Project: ELON HAWK RIDGE POLO RELIEF ES

Submittal No. / Revision: 237412-1 1 Subcontractor/Supplier: Superior Mechanical Systems (Charlotte)	Description: Single Zone Packaged Rooftop Units - Product Data
Submittal Type: Product Data Spec. Section & Paragraph No.: 237412	Required on site by: Required lead time: Status: Submitted to AE
Notes: A. Product Data: Include manufacturer's technical data for each RTU, including rated capacities, dimensions, required clearances, characteristics, furnished specialties, and accessories.

In accordance with Specification SECTION 237412
SINGLE ZONE PACKAGED ROOFTOP UNITS

CONNECTION SIZES	
E	3/4"-14 NPT CONDENSATE DRAIN

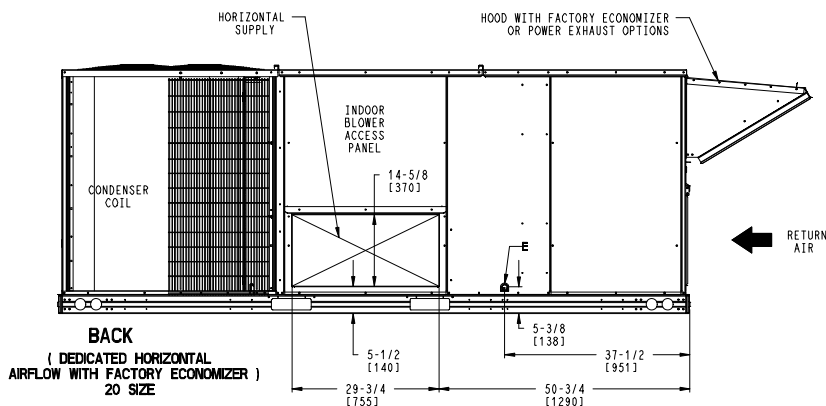
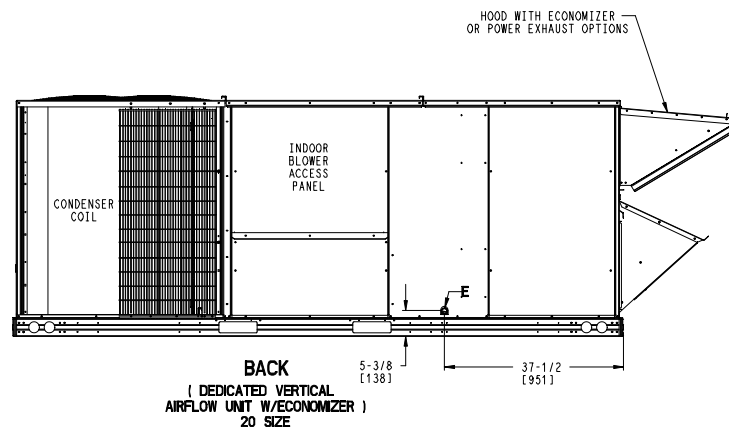
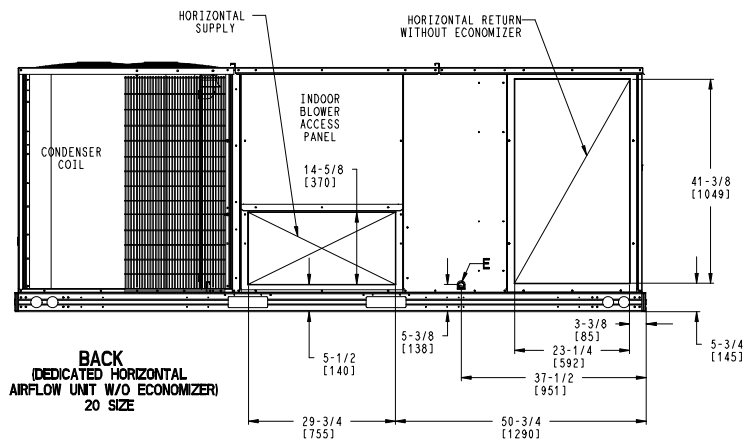
Schedule calls for stainless steel drain pan
